Central Hudson Gas and Electric Corporation
A&C REBUILD PROJECT - ARTICLE VII APPLICATION
Case 13-T-0469

INTERROGATORY/DOCUMENT REQUEST

Requesting Party and No.: DPS Staff - DPS-001 (MS)

Central Hudson Response No: CHGE-001 (DPS)

DRAWING TITLE: **R.O.W. CROSS SECTION AT PLASS ROAD INTERSECTION LOOKING SOUTH**

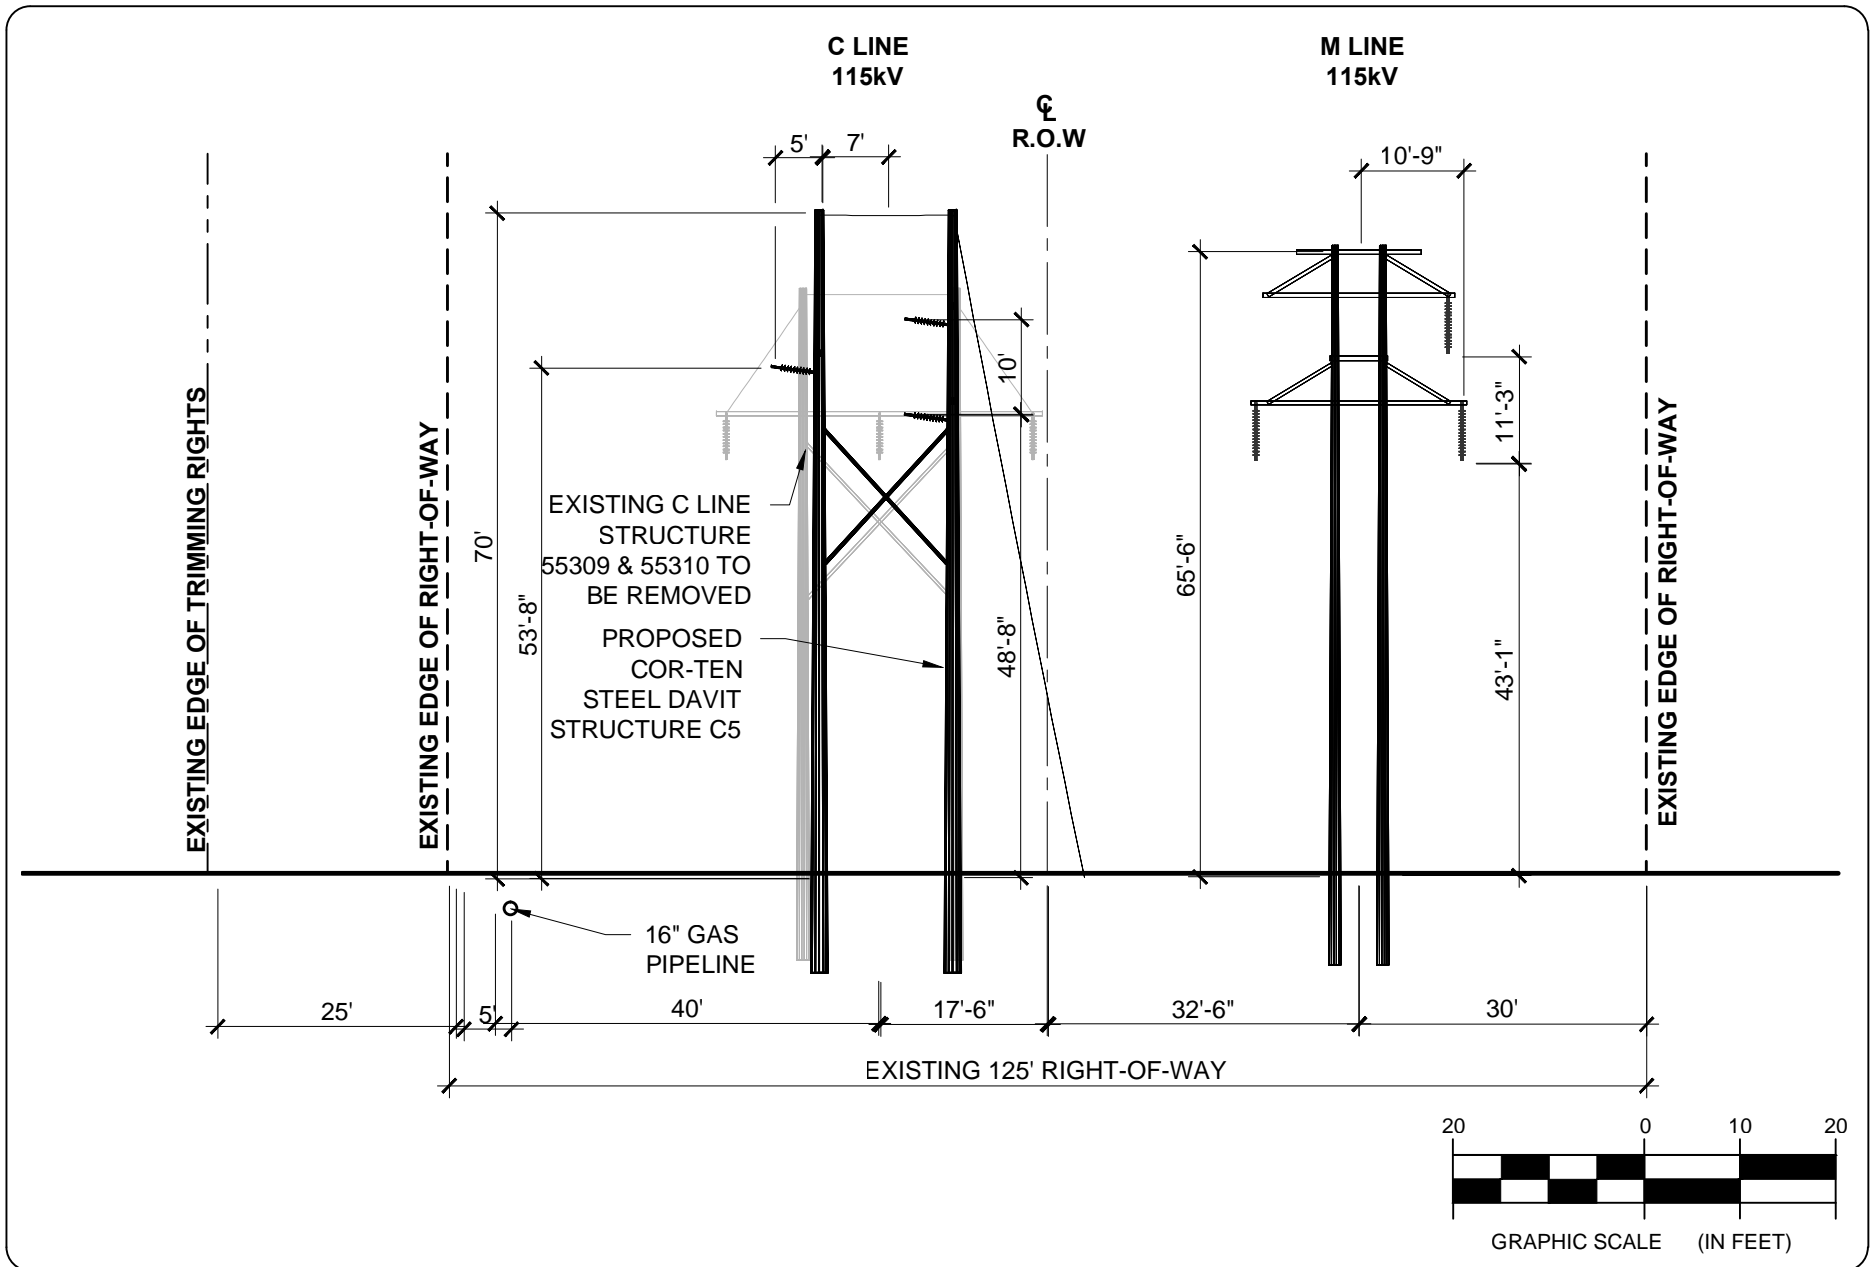
10. There appears to be a gas pipeline at Plass Road. This pipeline is not shown on any project drawings. Supply an updated look-down sheet(s) showing its location on the project ROW.

10. We understand that this question relates to Exhibits 8-04 and 8-05 attached to Central Hudson's January 13, 2014 filing. Revised Exhibits are attached as **Exhibit D** to this Response to show the referenced gas line (which is shown on the profile sheets contain in Appendix A to the Application, Sheet 1).

Invasive Species Documented within
State-Mapped Wetlands and Streams

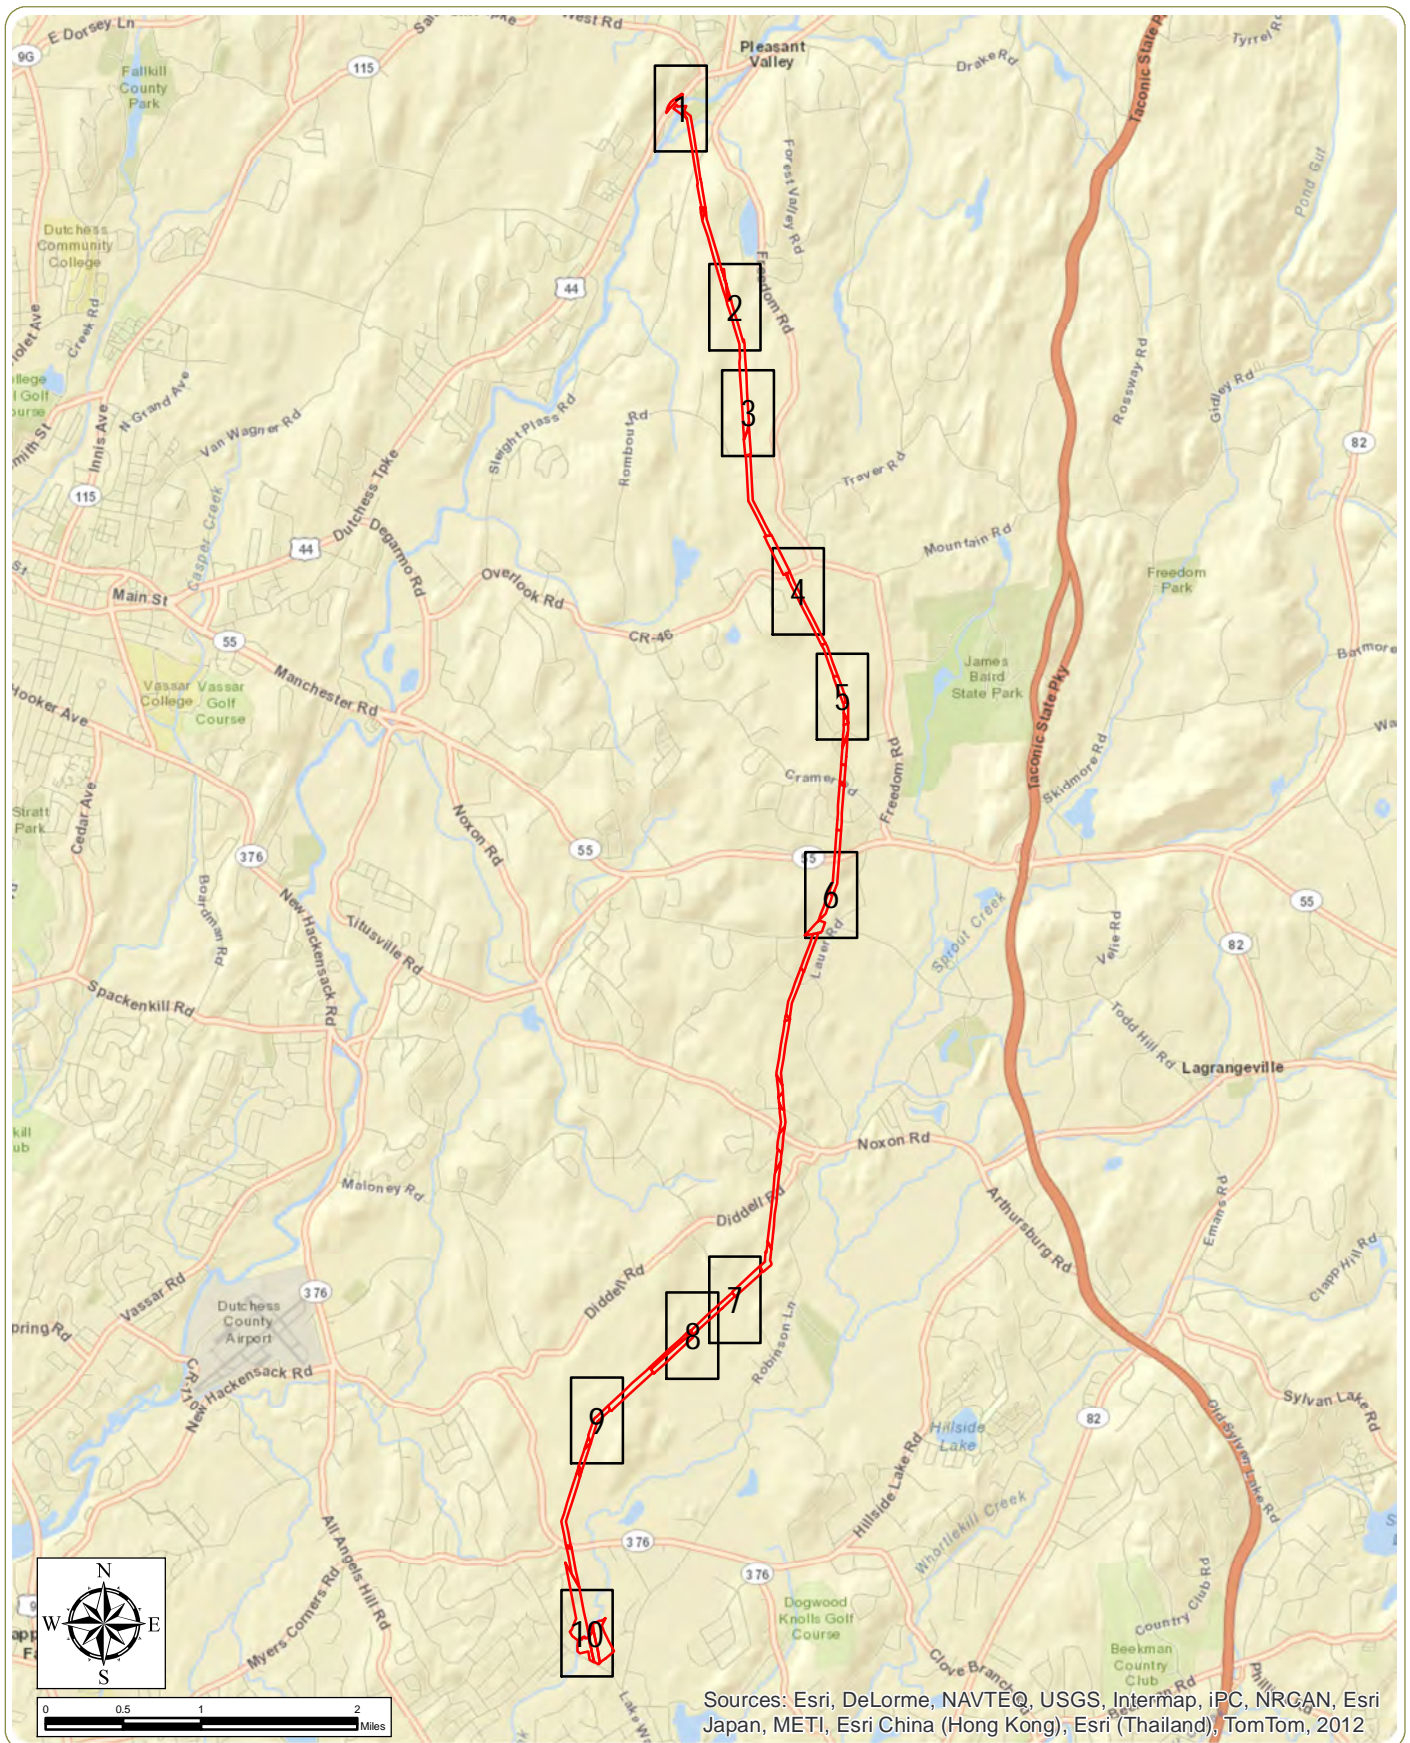
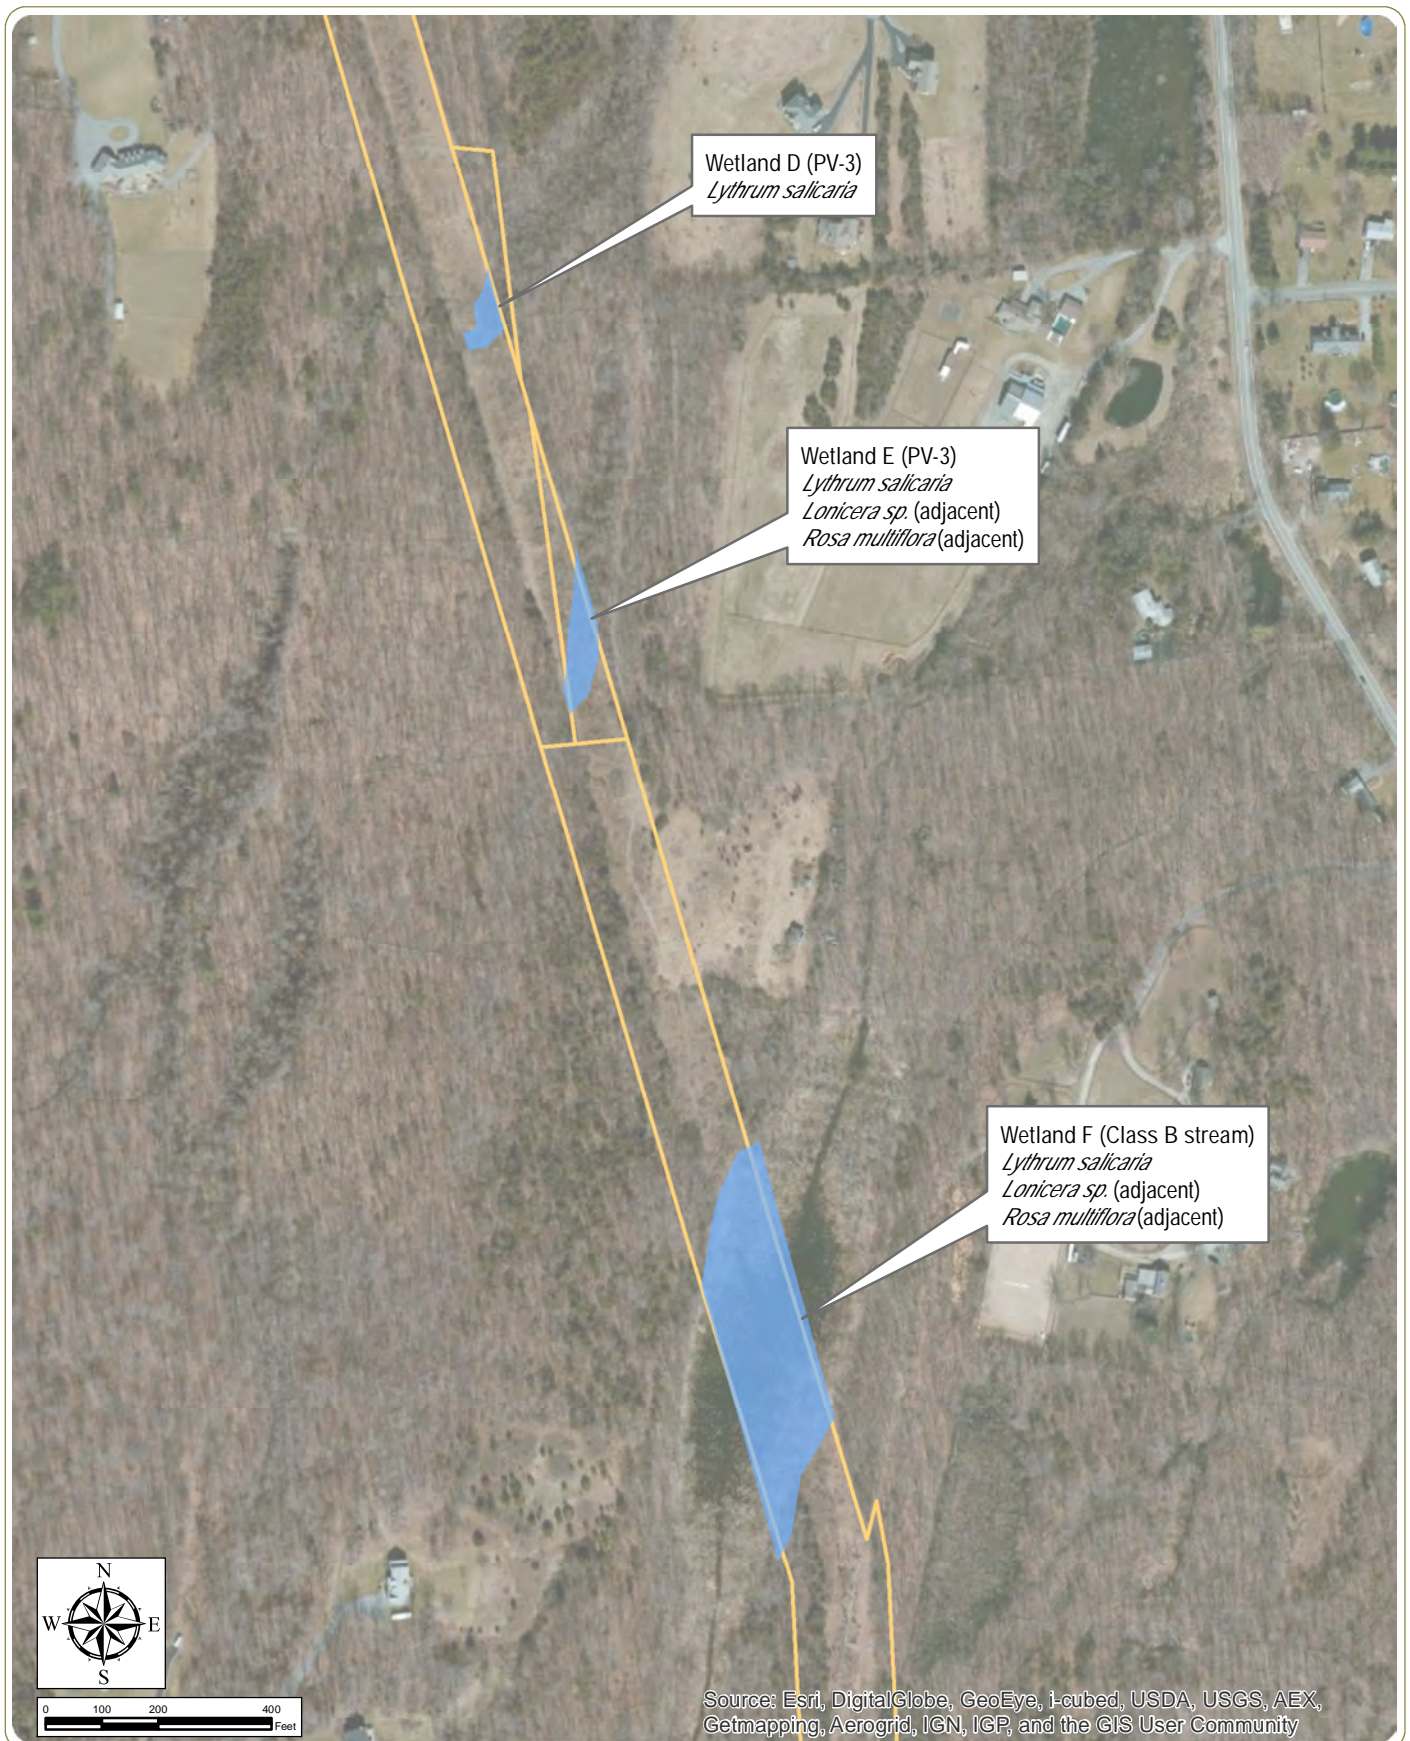
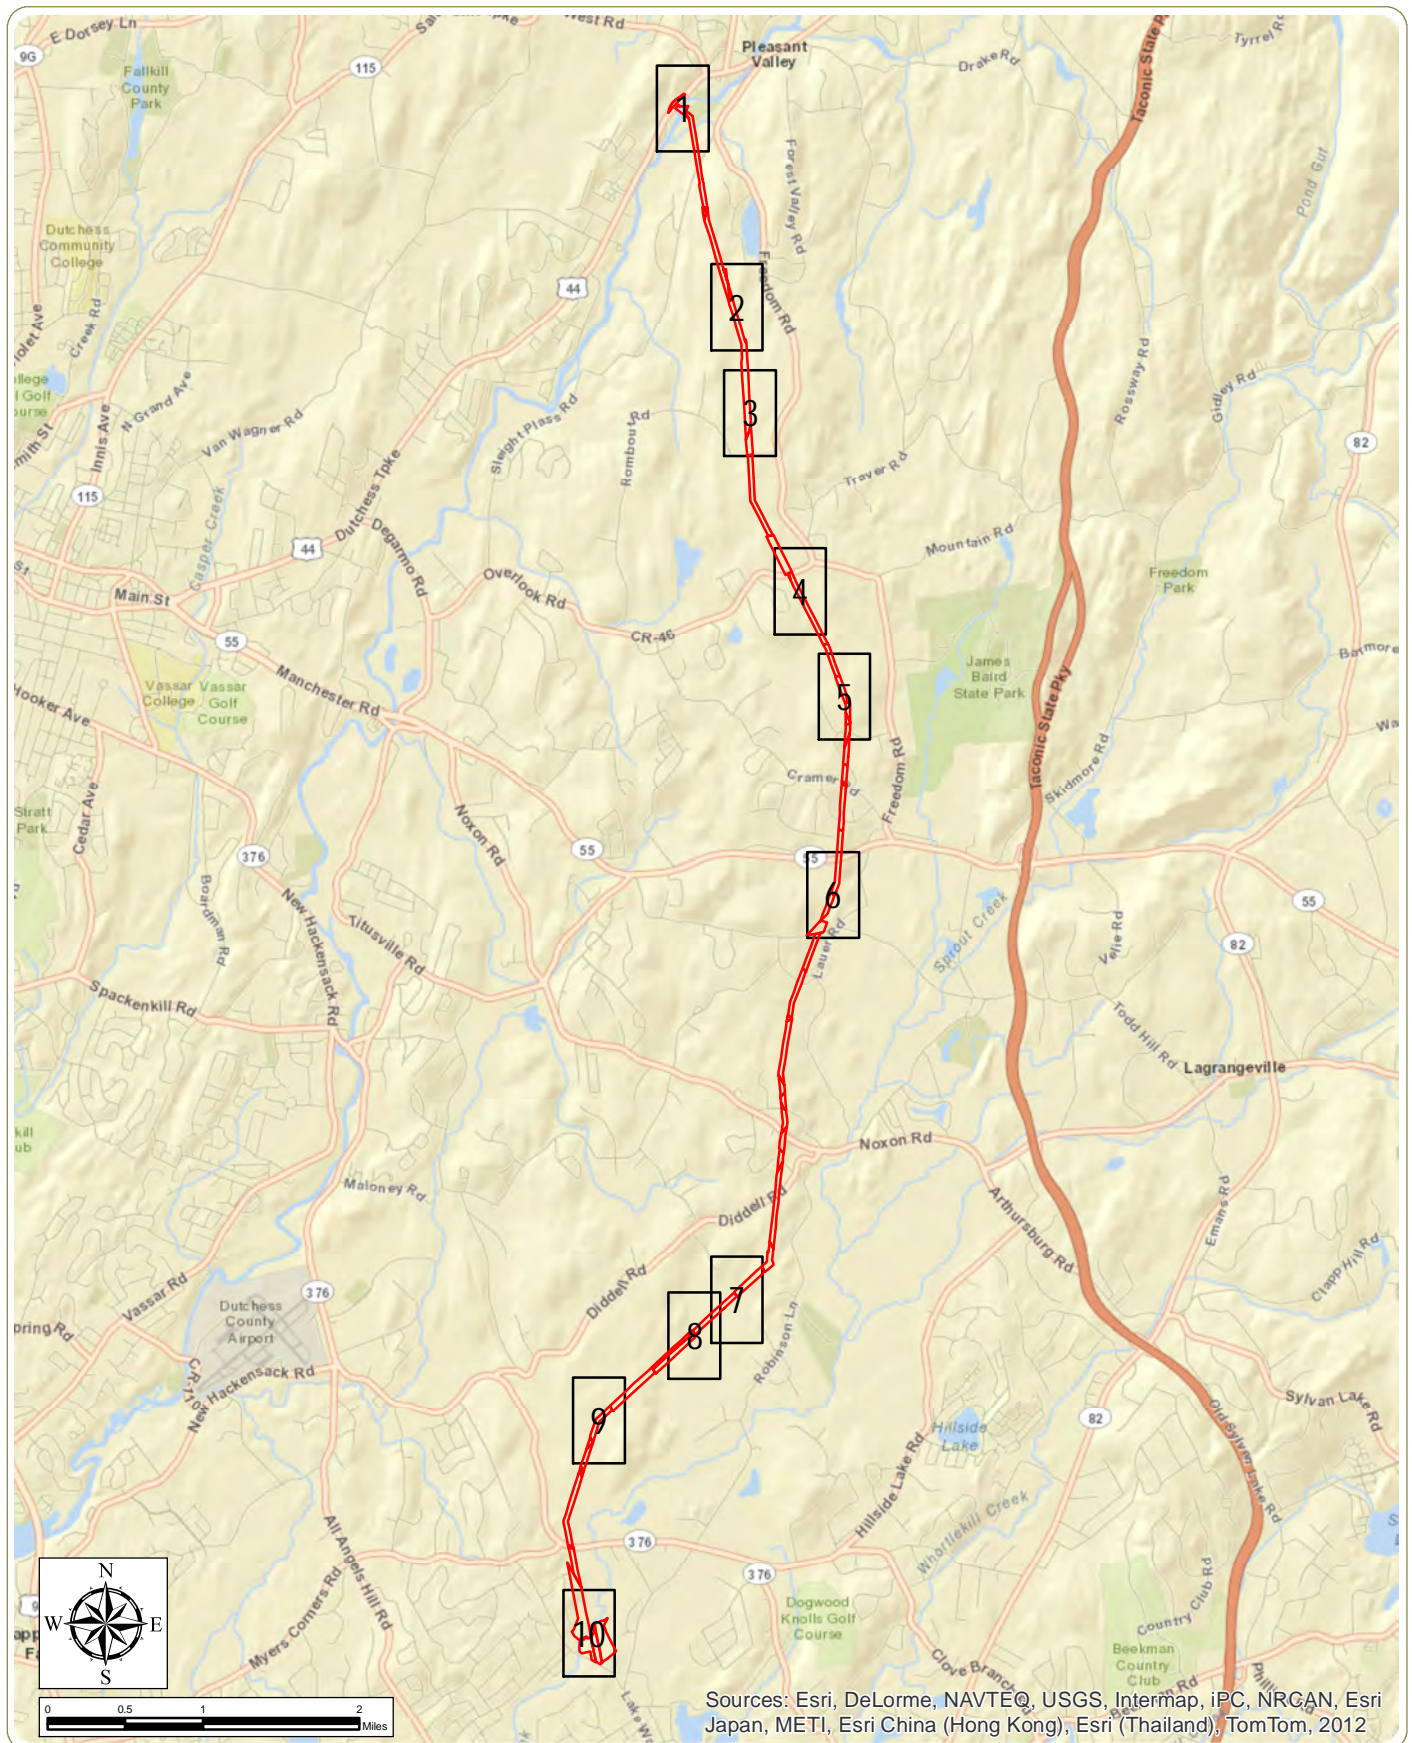
17. Provide a project ROW map locating each State wetland and protected stream, and list any invasive species occurring within each of those areas.
18. For general 115 kV construction does the Company use any of the following types of structures or foundations:
